ND-16-2481
10 CFR 50.71(e)
50.55(f)(4)(i)

Southern Nuclear Operating Company
Vogtle Electric Generating Plant Units 3 and 4
Nuclear Development Quality Assurance Manual, Version 15.0

Enclosure: NDQAM Version 15.0 (with revision bars)

**Figure II.1-1
SNC Organization**

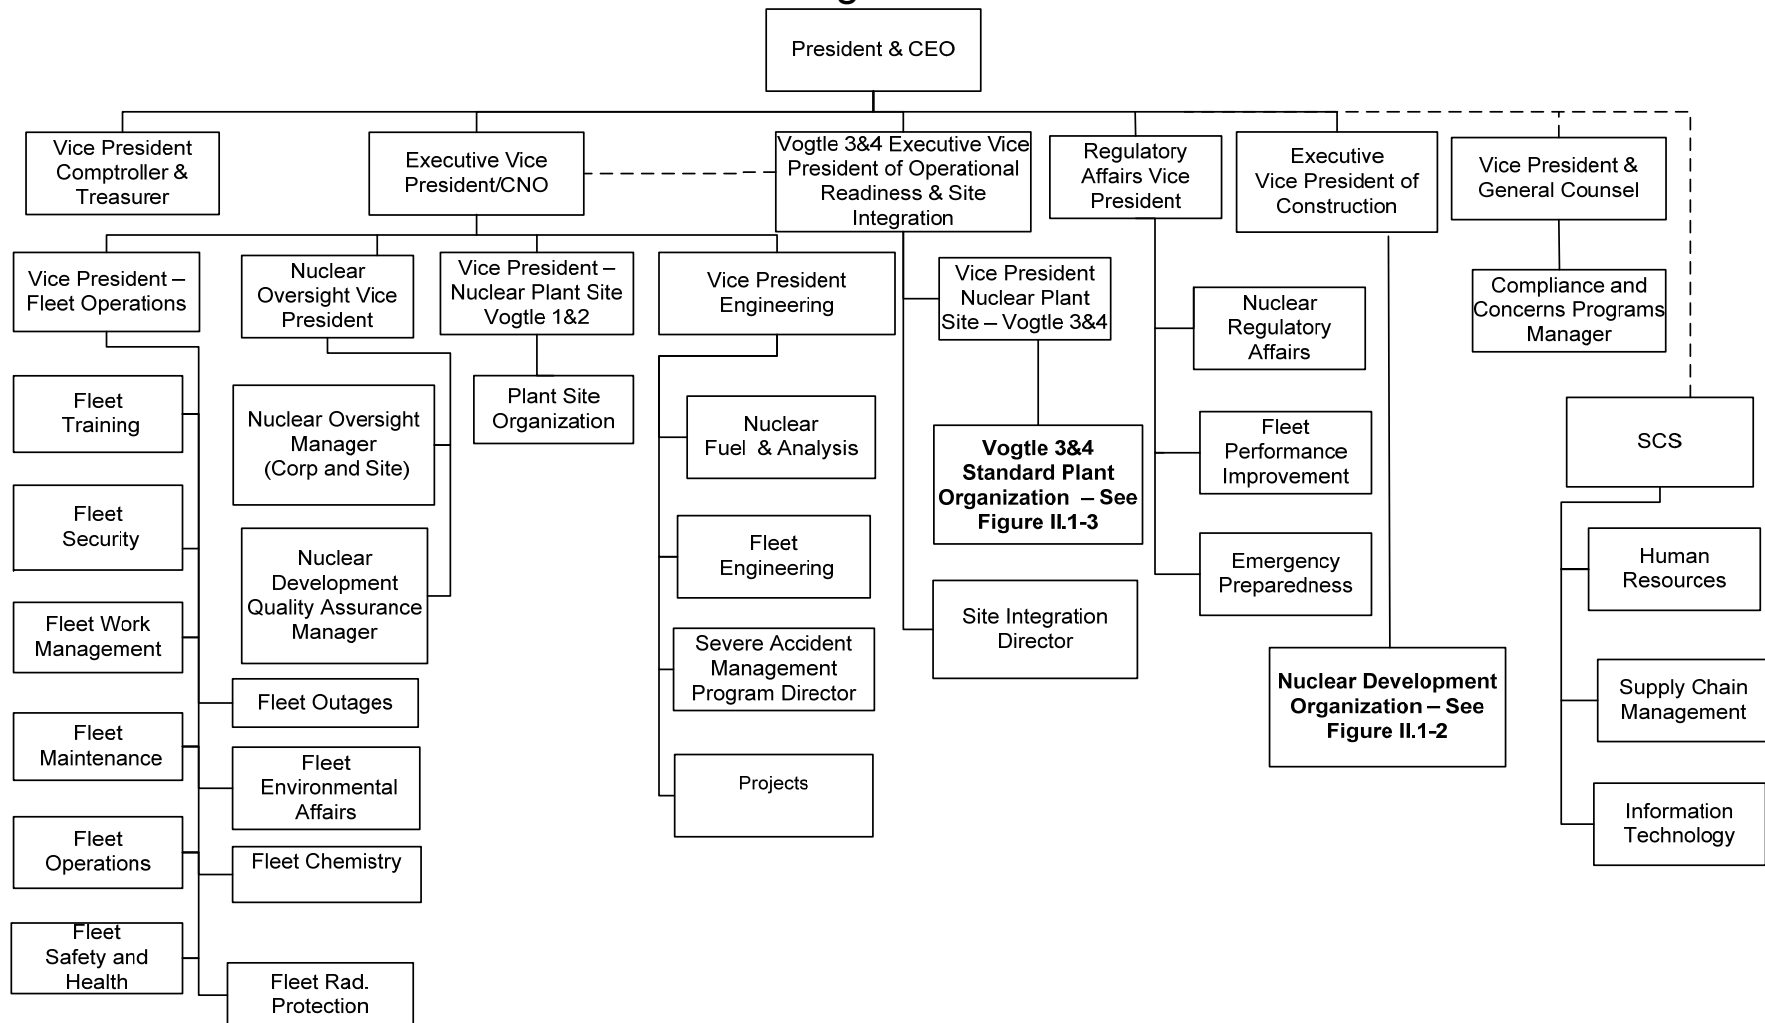
- Figure II.1-1 through II.1-3 updated to align with NDQAM text.
- Figure II.1-1 Changes:
 - Add Vogtle 3&4 to Executive Vice President of Operational Readiness & Site Integration

- Remove “Support” from Vice President – Fleet Operations title
 - Add “Management” to Supply Chain
 - Add “Programs” to Compliance and Concerns
 - Change Nuclear Licensing to Nuclear Regulatory Affairs

- Change Nuclear Fuel Director to Nuclear Fuel & Analysis
 - Remove “Services Director” from Fleet Engineering
 - Delete Risk Informed Engineering Director

- Delete Fleet Design Director
- Change Major Projects Manager to Projects
- Separate Env. Affairs, Chemistry, and Rad Services into three organizations. Fleet Environmental Affairs, Fleet Chemistry, and Fleet Rad. Protection.

- Add Fleet outages
- Add Fleet operations
- Remove "Nuclear" from Fleet Security
- Change Industrial Safety to Fleet Safety and Health
- Figure II.1-2 Changes:

Figure II.1-2
Nuclear Development Organization

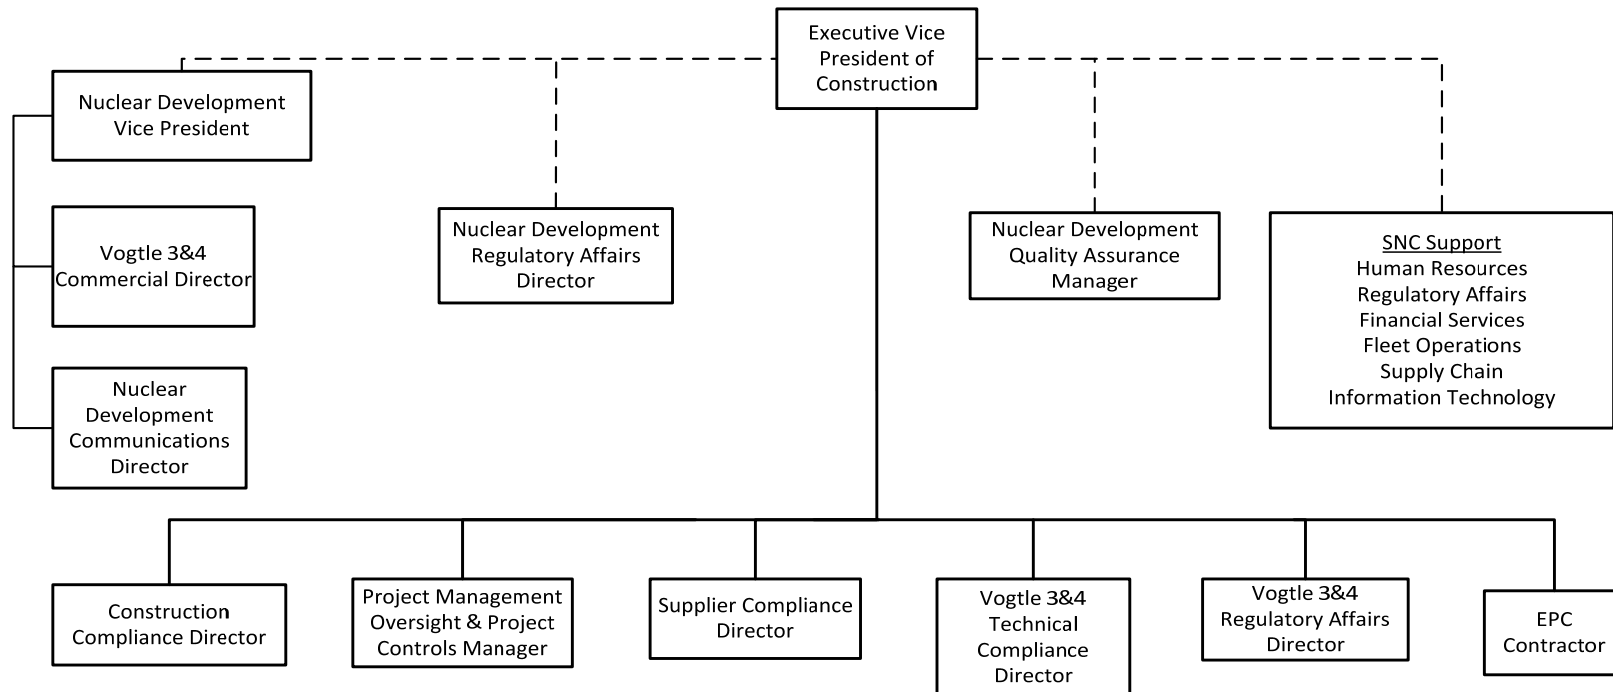
- Remove all bullets at bottom of figure
 - Remove QA Project Manager
 - Remove Associate General Counsel
 - Add the following to SNC Support:
 - Information Technology

- Remove the following from SNC Support:
 - Compliance
 - General Counsel
 - Add Vogtle 3&4 to Technical Compliance Director
 - Remove Legal Counsel
 - Remove SCS Support IT

- Remove Executive Vice President of External Affairs for Georgia Power
 - Add Vogtle 3&4 to Commercial Director
 - Remove Project information Management Director

- Remove Nuclear Development Regulatory Manager
- Figure II.1-3 Changes:
 - Change AP1000 Training Deployment Manager to Training Director
 - Change Senior Manager Responsible for Operations to Operations Director

Figure II.1-3
Vogtle 3 & 4 Standard Plant Organization (Operations)

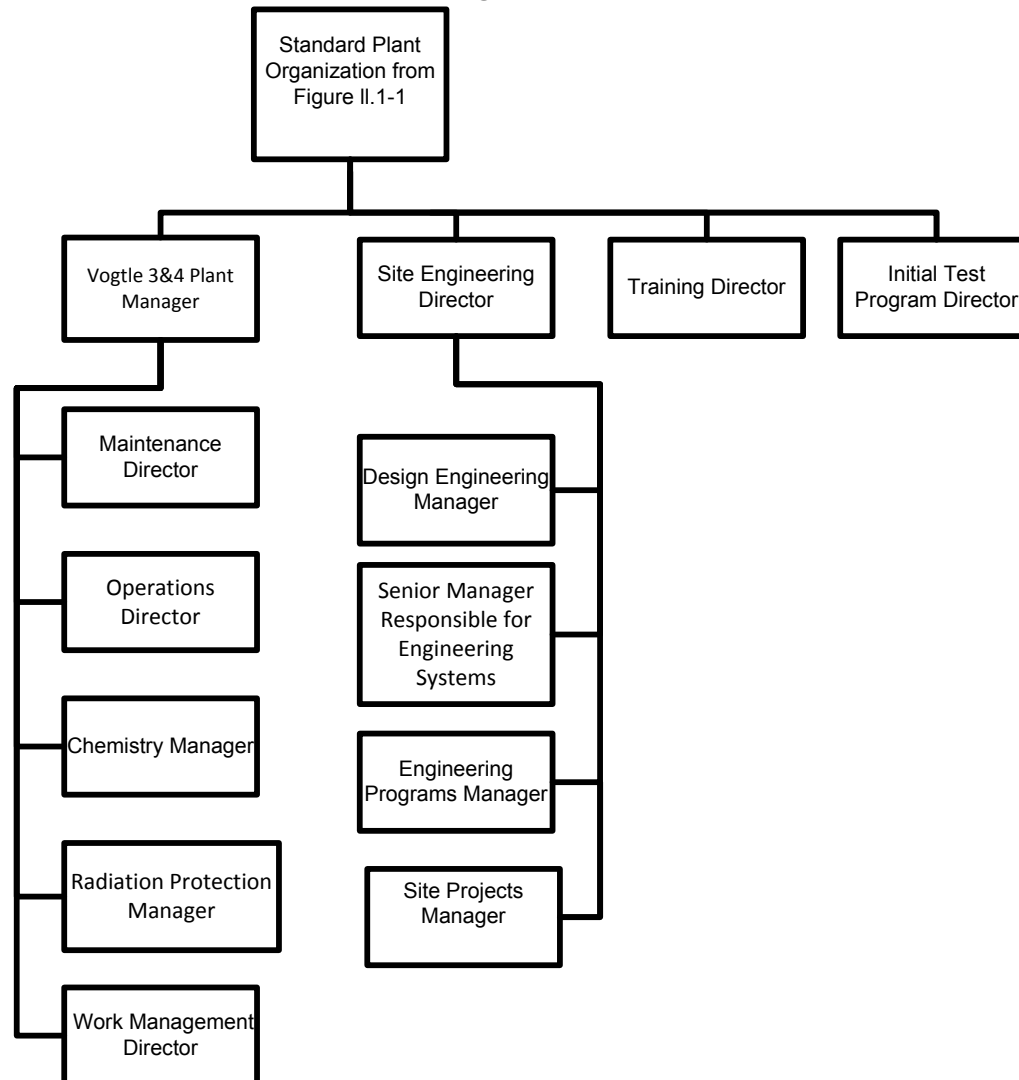
- Change Senior Manager Responsible for Radiation Protection to Radiation Protection Manager
 - Change Senior Manager Responsible for Work Management to Work Management Director

- Add Vogtle 3&4 to Plant Manager
 - Remove Cyber Strategy Director
- 5. Part II, Section 2, QUALITY ASSURANCE PROGRAM: Issuance and Revision to Quality Assurance Program Description.
